Submission to the Australian Energy Regulator (AER)

**Response to proposals from Victorian electricity distribution
network service providers for a revenue reset for the financial
years 2022-2027 regulatory period**

**Brotherhood of St Laurence
Victorian Council of Social Service
Renew**

May 2020

Figure 15 Peak non-coincident raw demand

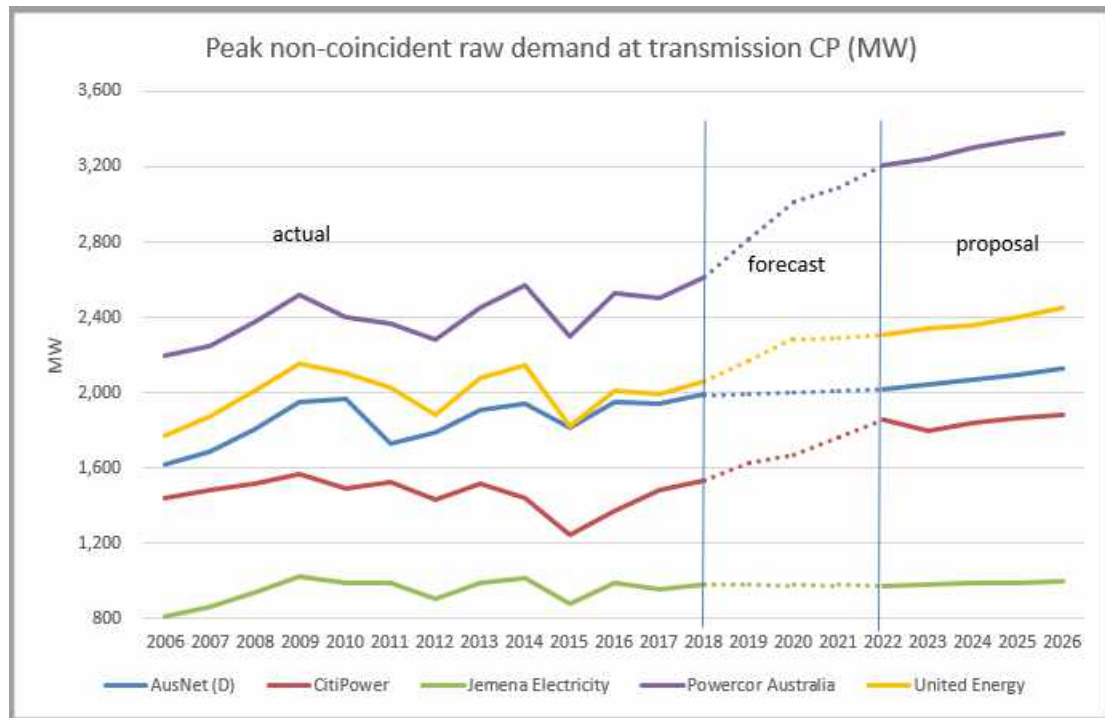
The chart shows that AusNet is expecting only minimal growth in peak demand and Jemena expects the same. In contrast Powercor, CitiPower and United all indicate a massive increase in peak demand from 2018 to the start of the next regulatory period with further growth thereafter.

Figure 17 Energy delivered

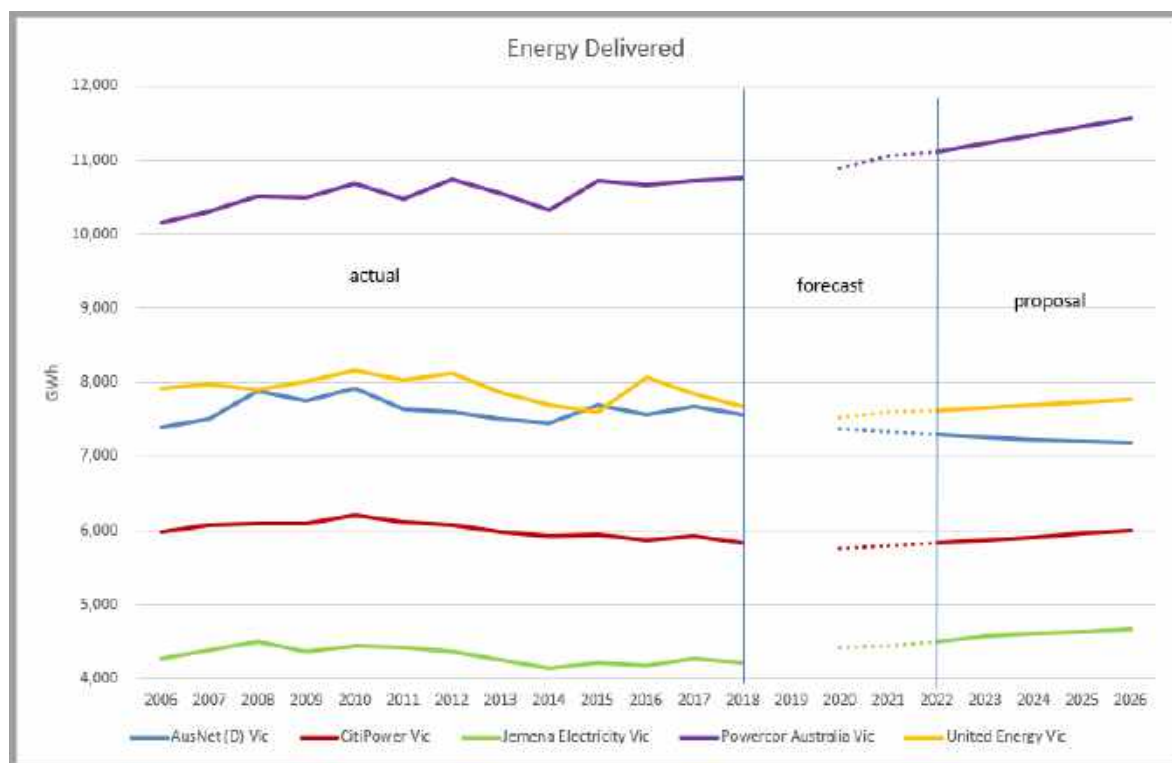
This shows that all DBs except are forecasting increasing amounts of energy to be delivered to their customers. This is seemingly inconsistent with the generally accepted view that energy demand is either static with time or falling since the early part of this decade. In fact, with increasing penetration of distributed energy resources (particularly roof top solar) the fall in energy delivered is to be expected.

Figure 23 – AusNet Services opex (\$2021m)

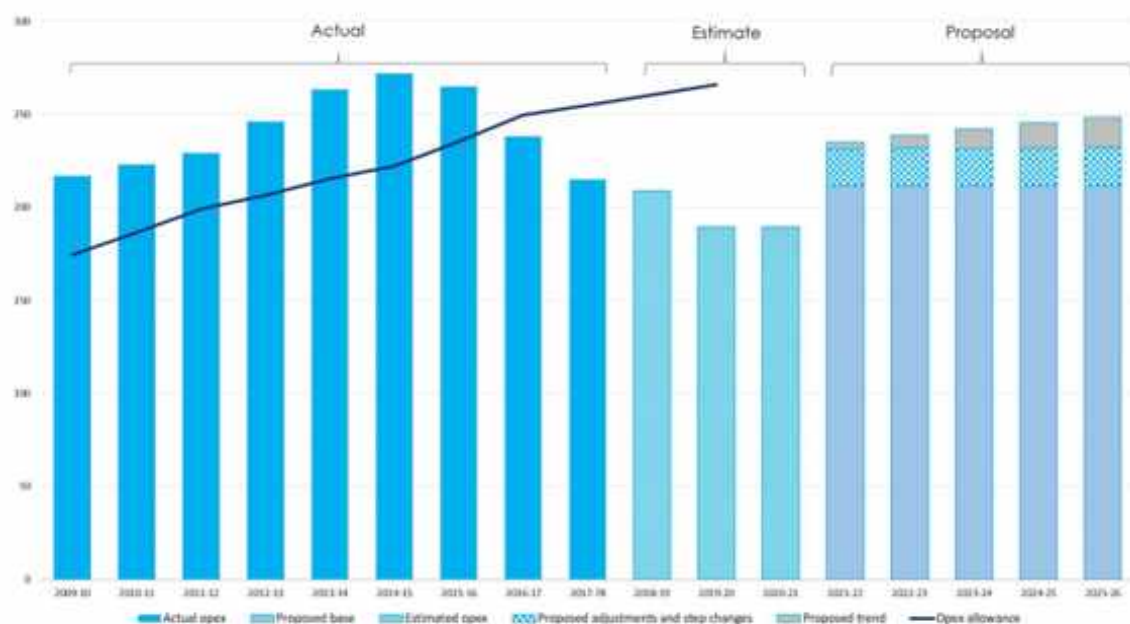
AusNet has decided that 2018 demonstrates an efficient base year as it exhibited lower opex than in the previous two years. This contradicts the information provided by AusNet in figure 16 from the AER Issues Paper which shows that in real terms forecast opex in 2019 would be a lower amount.

Figure 24 – CitiPower opex (\$2021m)

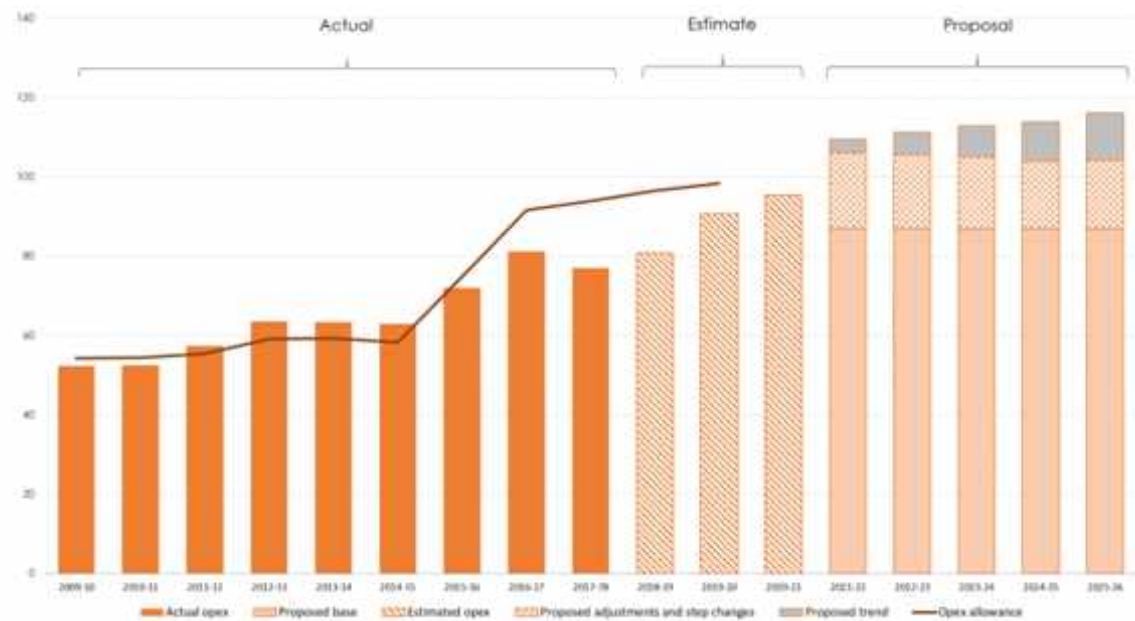
CitiPower has elected to use its 2019 opex as the base year for forecasting its future opex needs. Intriguingly, CitiPower uses the long term average performance of its opex based on the efficiency scores from its Cobb-Douglas stochastic frontier analysis to show it is the second most efficient network in the NEM, even though the PFP analysis shows it is currently the most efficient.

Figure 25 – Jemena opex (\$2021m)

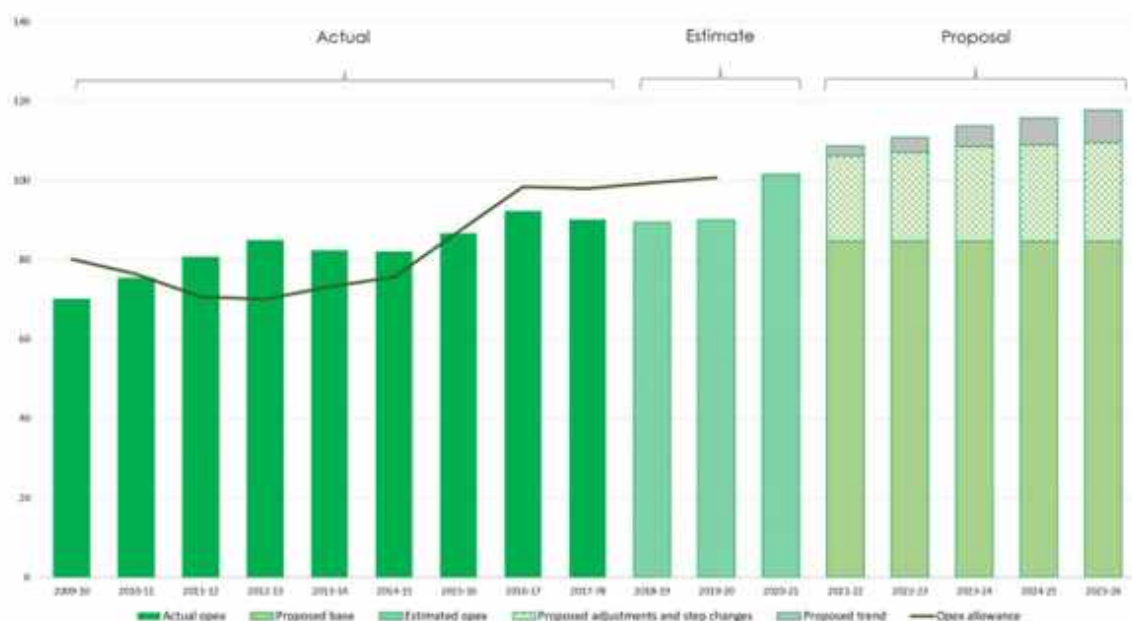
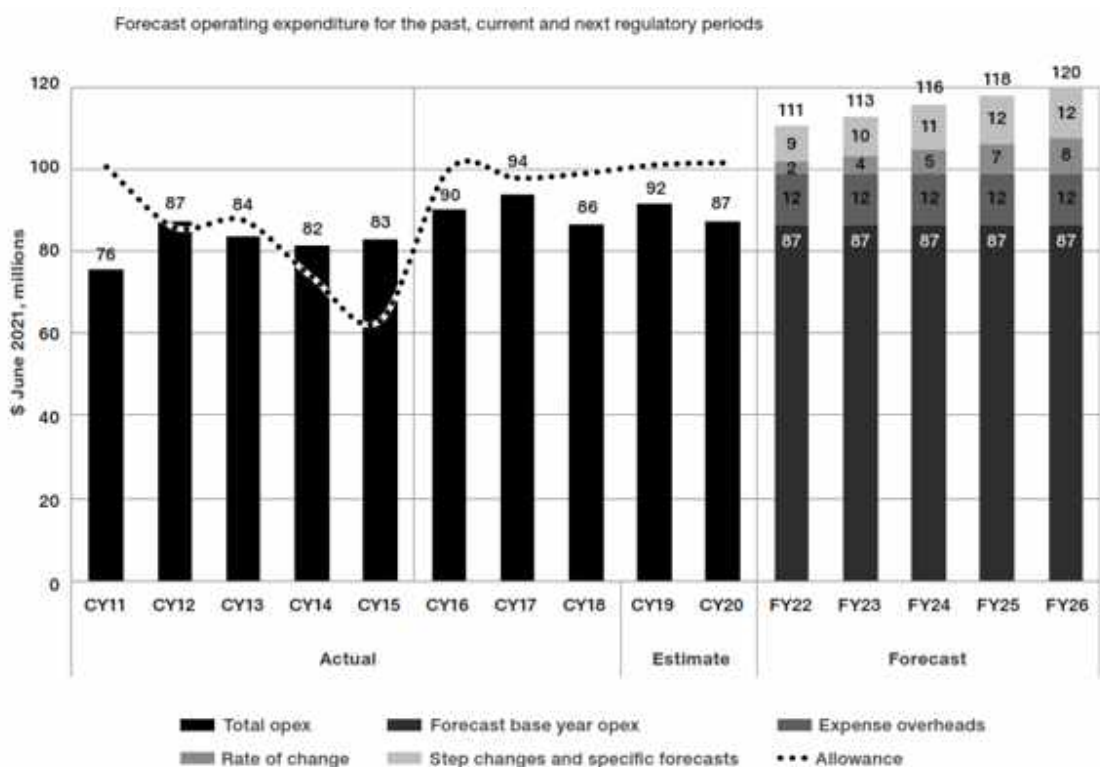
Jemena proposes to use 2018 opex as its base year. This is acceptable when considering the actual opex over time as shown by Jemena in figure 17 from the AER Issues paper. What is interesting is that despite the AER considering that 2019 opex will be the same as 2018 opex, Jemena in its figure 6.2 shows a distinctly higher opex in 2019.

In contrast, Jemena provides a similar chart but with some stark differences

Figure 27 – Powercor opex (\$2021m)

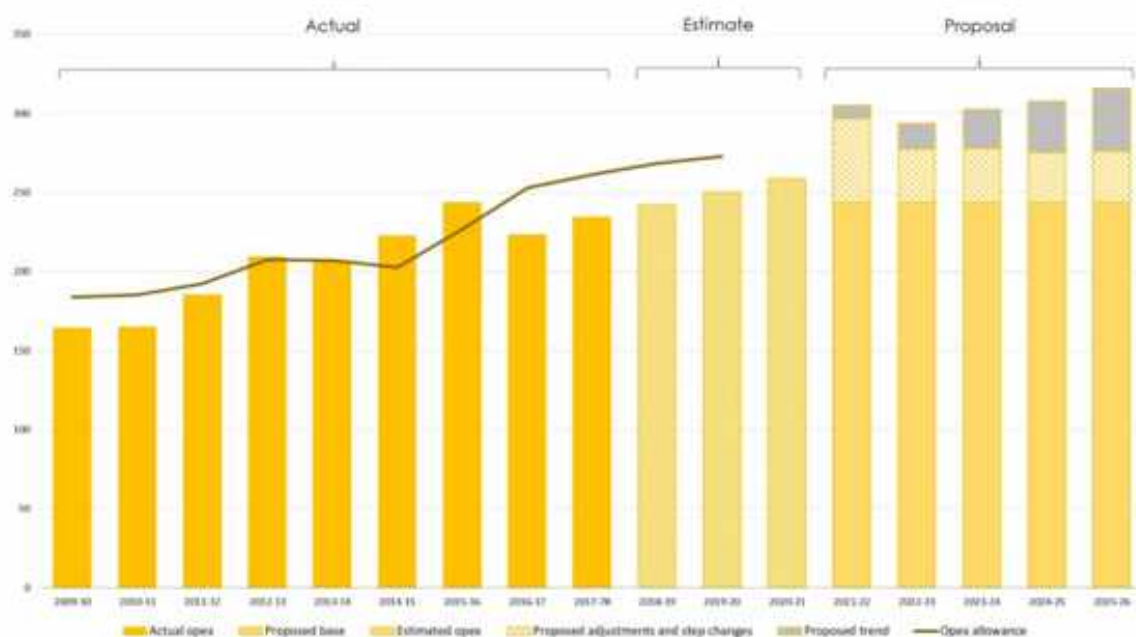
Powercor has elected to use its 2019 opex as the base year for forecasting its future opex needs. As with CitiPower, Powercor uses the long term average performance of its opex based on the efficiency scores from its Cobb-Douglas stochastic frontier analysis to show it is the most efficient network in the NEM, even though the PFP analysis shows it is currently the less efficient than the most productive (CitiPower).

Figure 28 – United Energy opex (\$2021m)

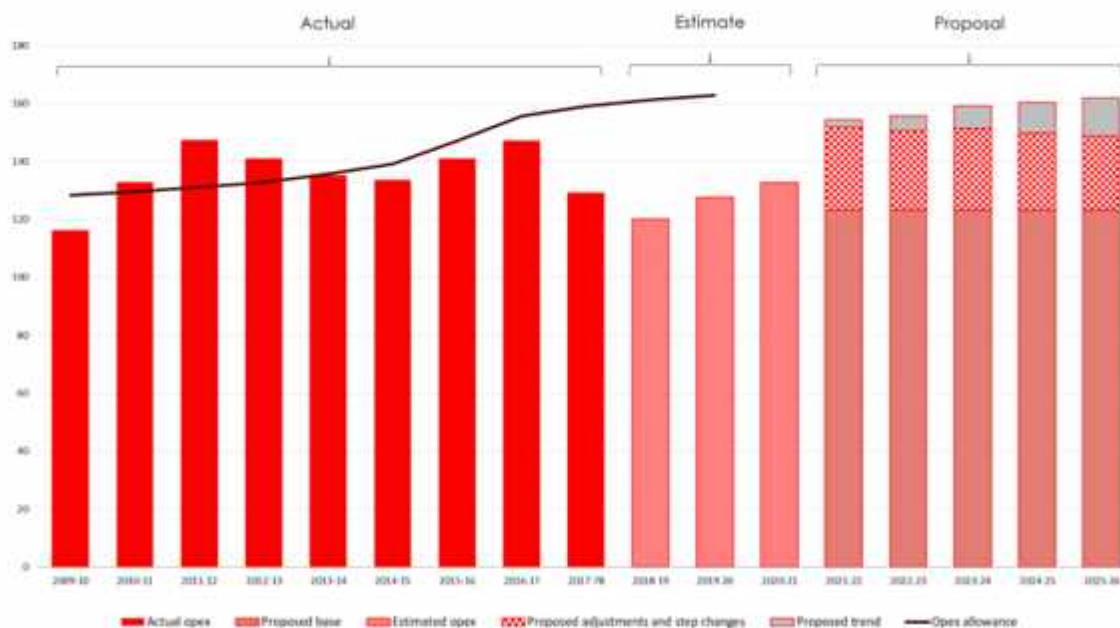
United has elected to use its 2019 opex as the base year for forecasting its future opex needs. As with CitiPower and Powercor, United uses the long term average performance of its opex based on the efficiency scores from its Cobb-Douglas stochastic frontier analysis to show it is the third most efficient network in the NEM (after CitiPower and Powercor), even though the PFP analysis shows it is currently the less efficient than the most productive (CitiPower).
